ATTACHMENT 1
NUREG-0654 COMPARISON WITH SHNPP
EMERGENCY ACTION LEVEL
FLOWPATH

FISSION PRODUCT BARRIER ANALYSIS

ATTACHMENT 2
SUMMARY OF CONTENT CHANGES
TO EMERGENCY ACTION LEVELS
(continued)

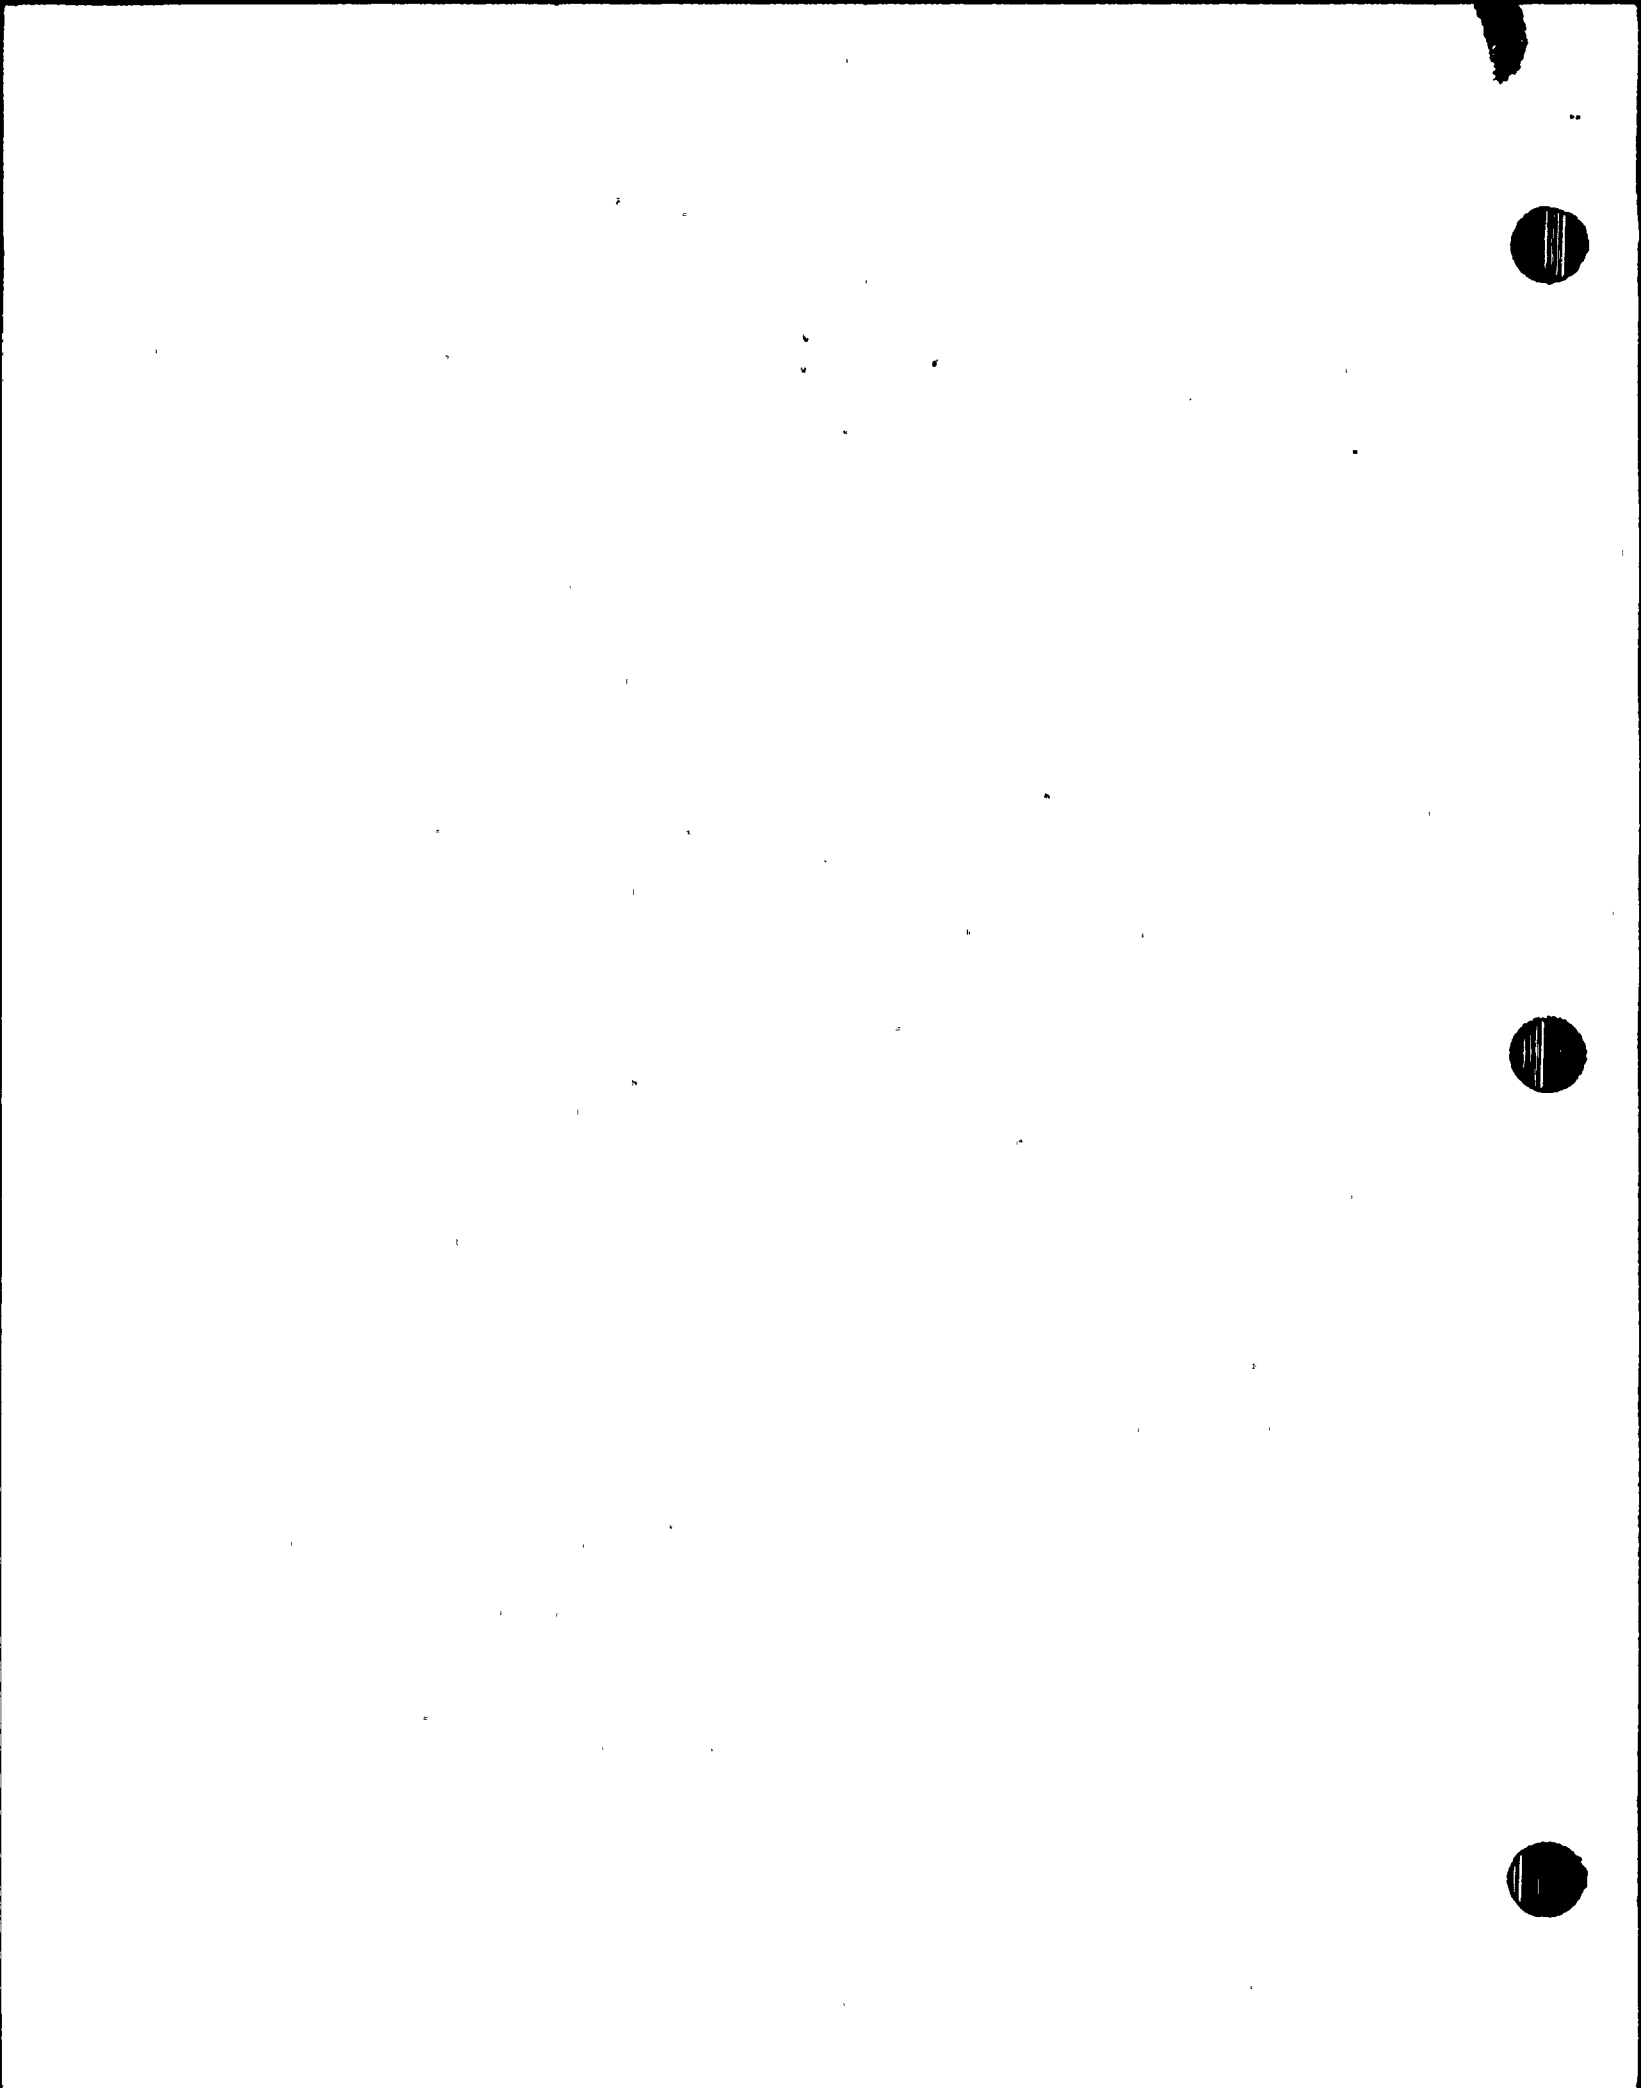
1. The emergency action levels for the condenser vacuum pump effluent treatment system radiation monitor and turbine building stack monitor were deleted. This emergency action level corresponded to a steam generator tube leak and normal activity in the RCS. The reason that this emergency action level was deleted is that it is too complicated and time consuming to determine whether the level is exceeded and is redundant to the existing emergency action level of a steam generator pressure greater than 1230 psig and a steam generator level greater than 82.4%. In order to properly establish an emergency action level based upon a turbine vent stack monitor reading, the current RCS activity must be known since the turbine stack monitor reading is a function of two variables, RCS activity and steam generator tube leakage rate. While the leak rate can be established into the action level, the activity in the secondary side can only be determined as a function of primary activity. Further, because the wide range turbine building stack monitor responds only to noble gas activity, a noble gas equivalent to the normally reported I-131 activity is needed, which is multiplied by 1500 to determine the actual emergency action level. The noble gas equivalent to an iodine activity is not calculated on a routine basis and in the event of a tube break would result in an event classification long after the steam generator level and pressure showed that a tube leak has occurred.

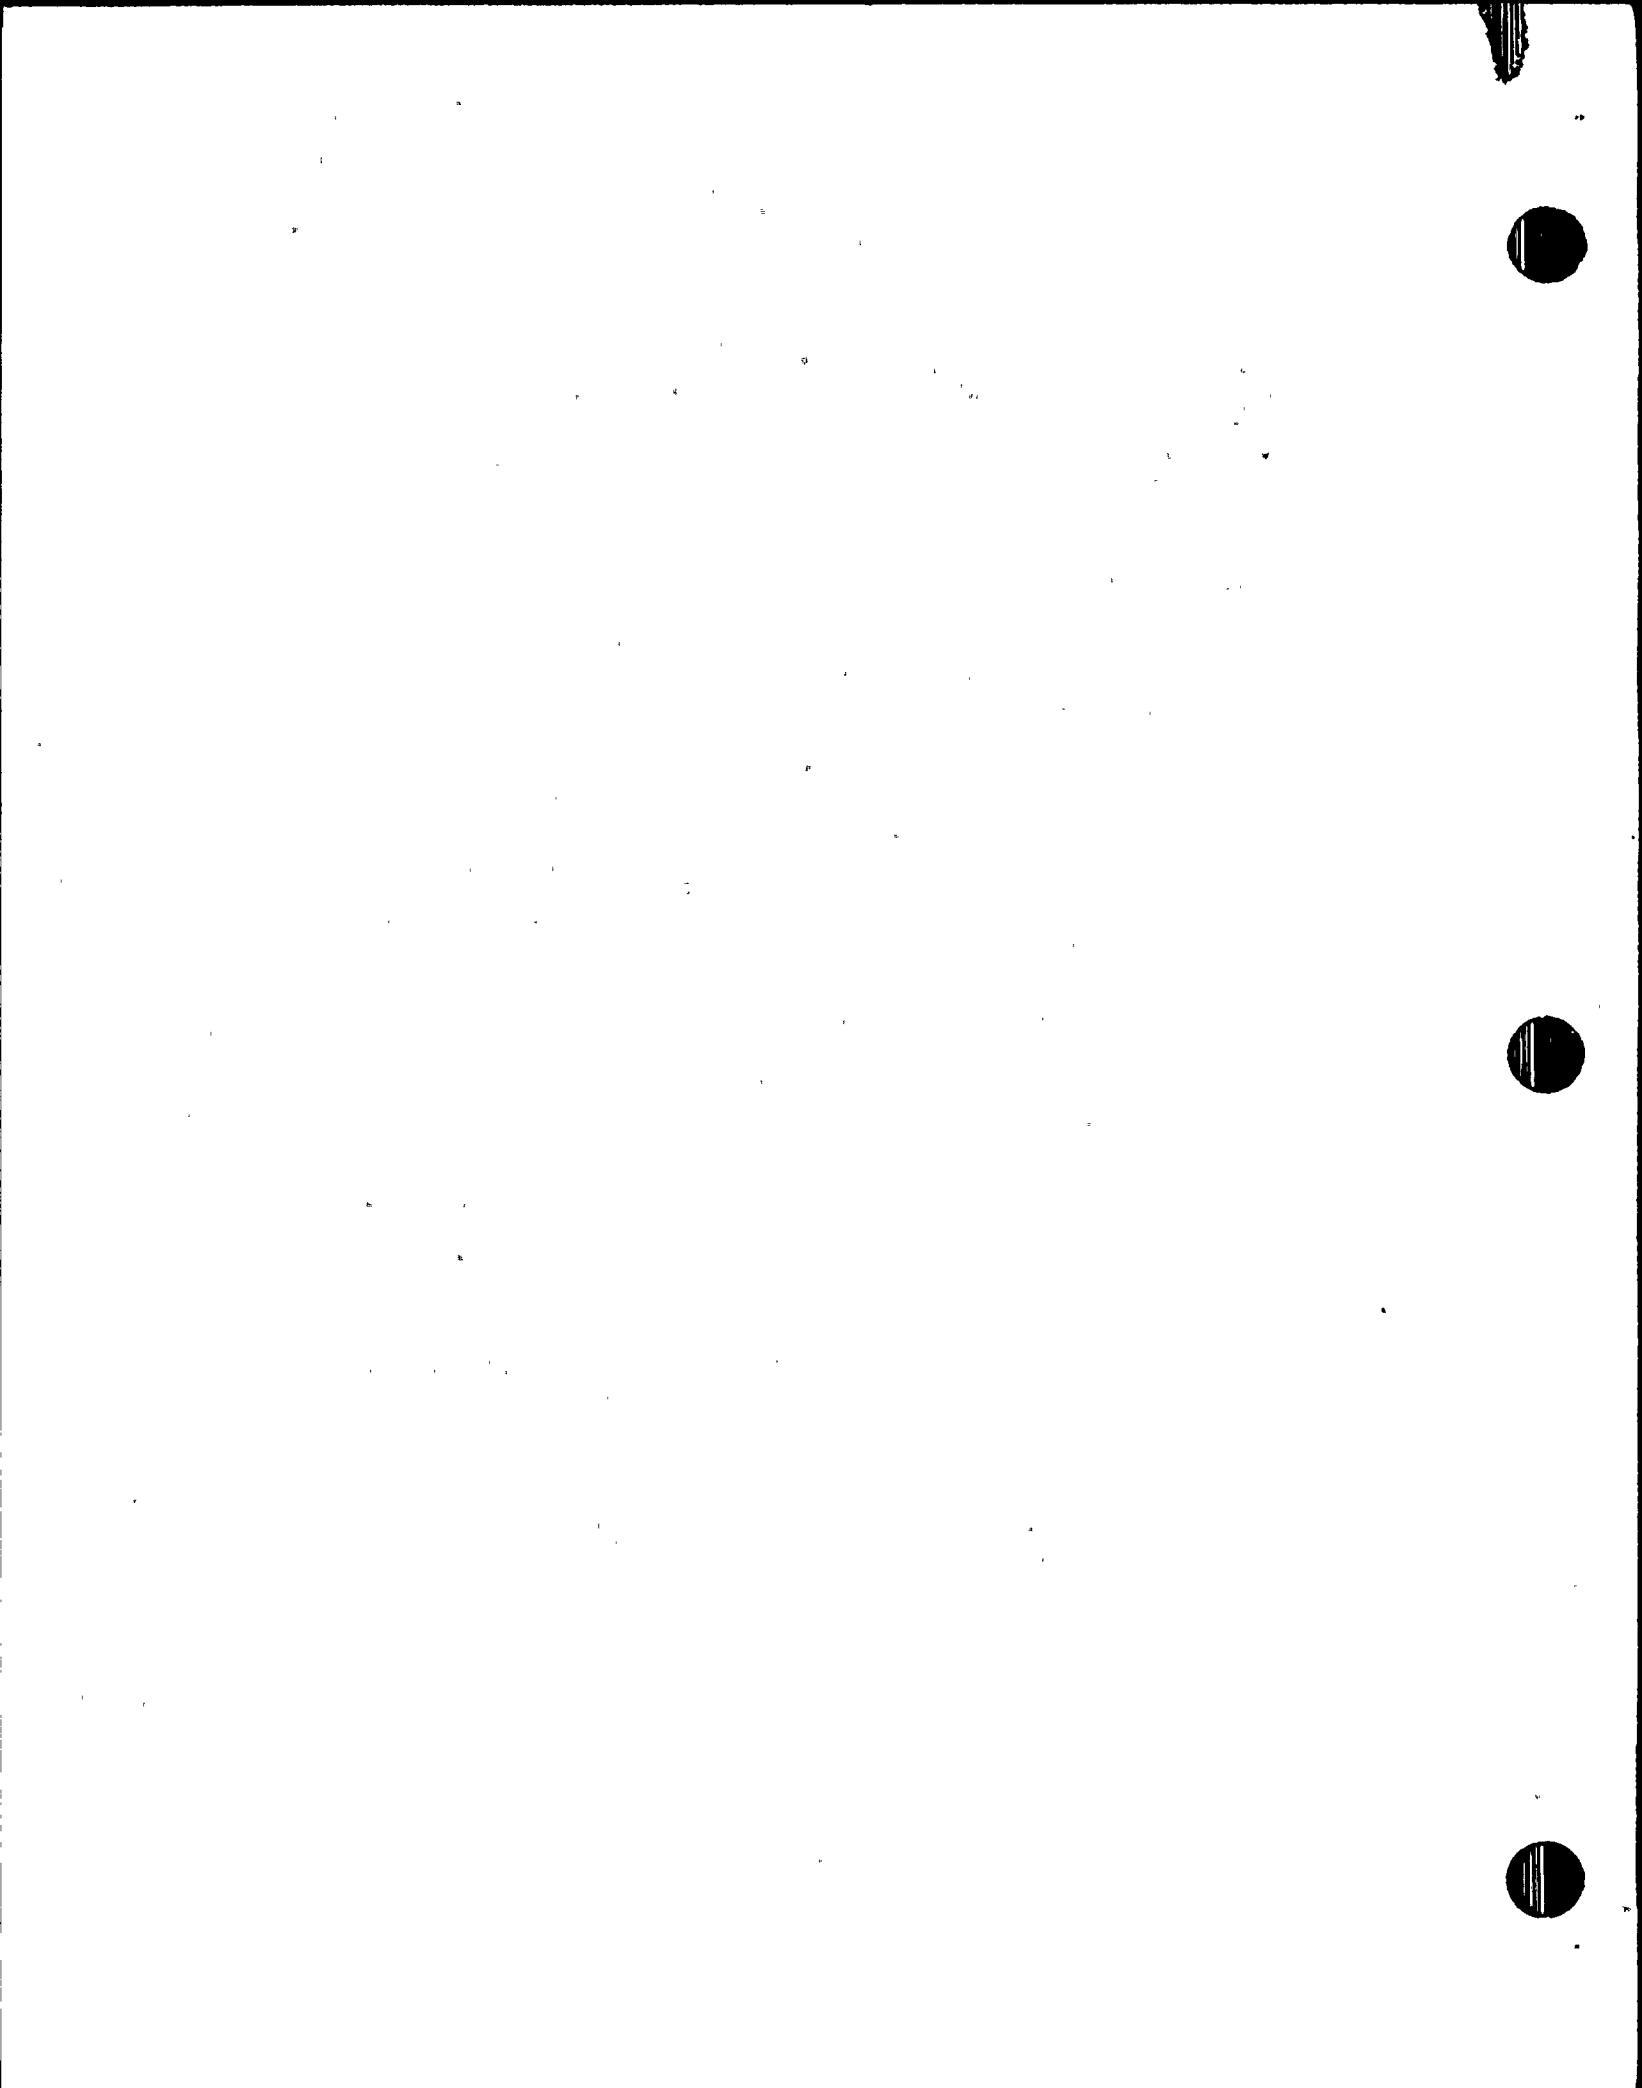
3. The following emergency action levels have been removed as redundant to "Initiation of any plant shutdown required by Technical Specification," which remains:
- Loss of Containment Integrity requiring shutdown by the SHNPP Technical Specification 3.6.
 - Loss of ESF requiring shutdown by the SHNPP Technical Specification; (e.g., because of malfunction, personnel error, or procedural inadequacy).
 - Loss of Fire Protection System function requiring shutdown by the SHNPP Technical Specification 3.7.10.
 - Other plant conditions exist that . . . require plant shutdown under SHNPP Technical Specification.
 - Loss of inputs from instrumentation included in the SHNPP Technical Specification 3.3 "Instrumentation to an extent requiring plant shutdown.

The deleted emergency action levels are entirely encompassed by the "initiation of a shutdown" emergency action level which is based upon 10CFR50.72 wording and invokes an Unusual Event declaration regardless of cause. The operating staff is taught to declare the Unusual Event when power begins to be reduced in response to any LCO requiring shutdown. While it is true that NUREG-0654 requires only a subset of Technical Specification shutdowns be declared as Unusual Events, the plant prefers the simplicity of declaring any such event. Further, the simplification of the Unusual Event matrix in this area will reduce confusion in interpretation inevitably caused by addressing the same issue six different ways. Also Technical Specification 3.7.10 no longer exists and all references to the Fire Protection and Detection Systems have been removed from the Technical Specifications.

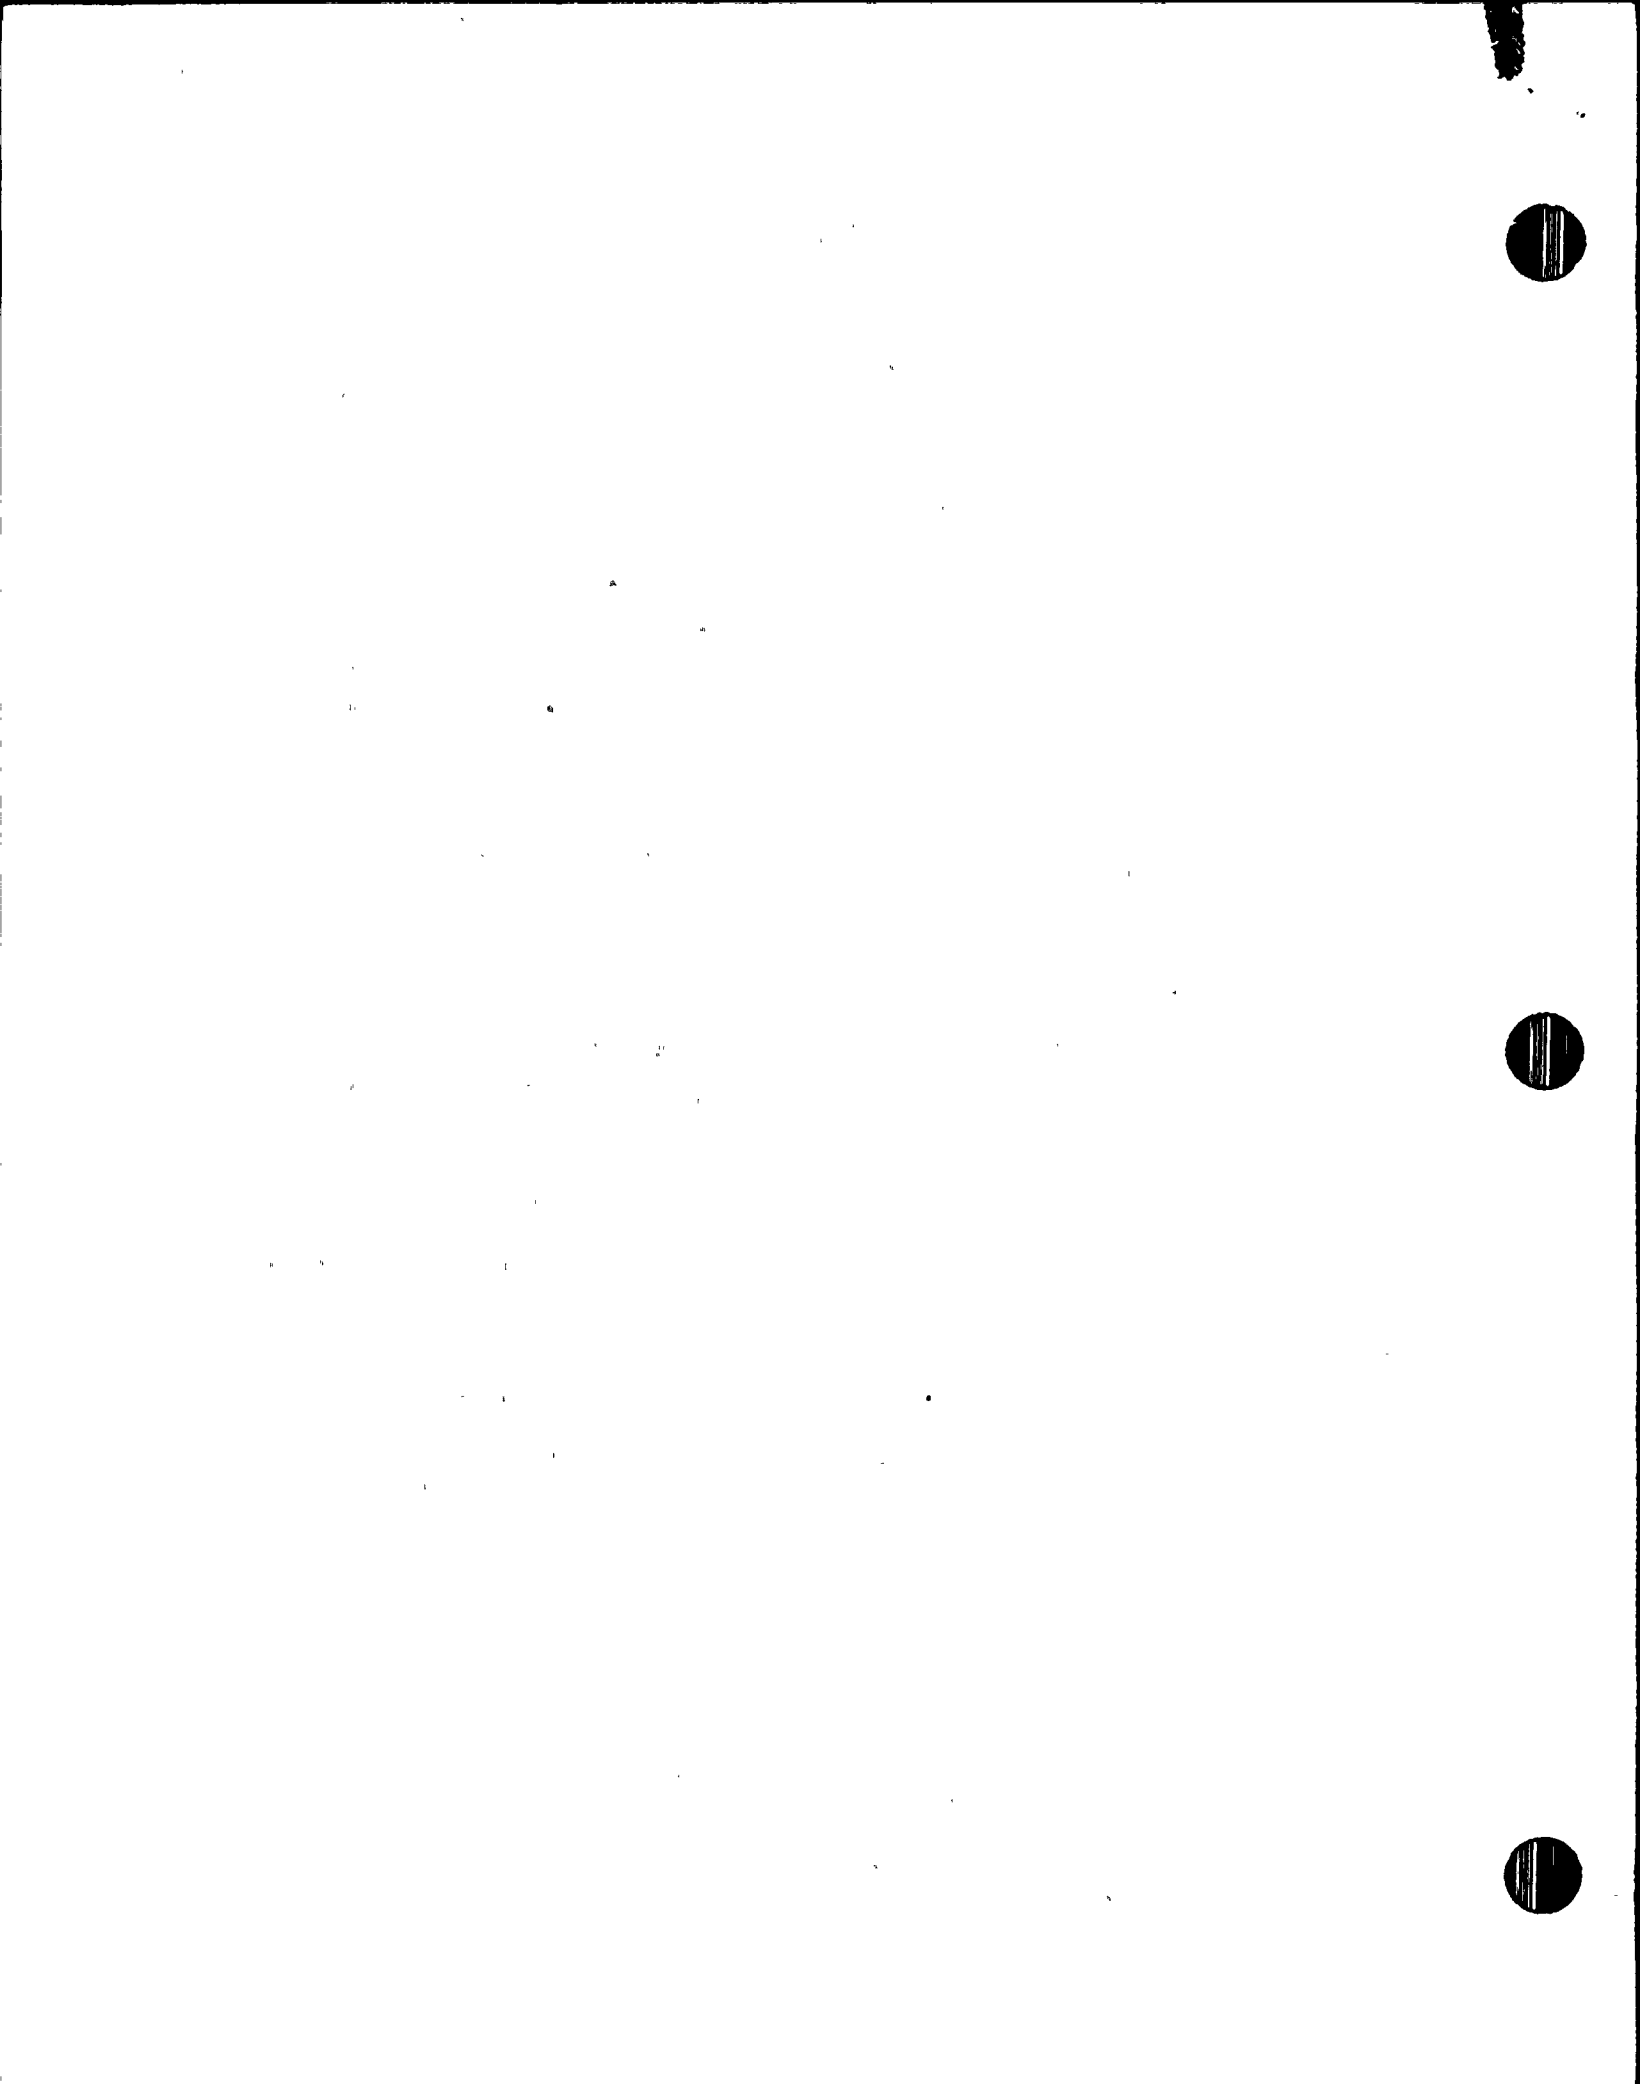
4. The site emergency action level for fuel handling accidents in the Fuel Handling Building has been reduced from 723 mR/HR to a conservative value of 700 mR/HR to improve human factors considerations.
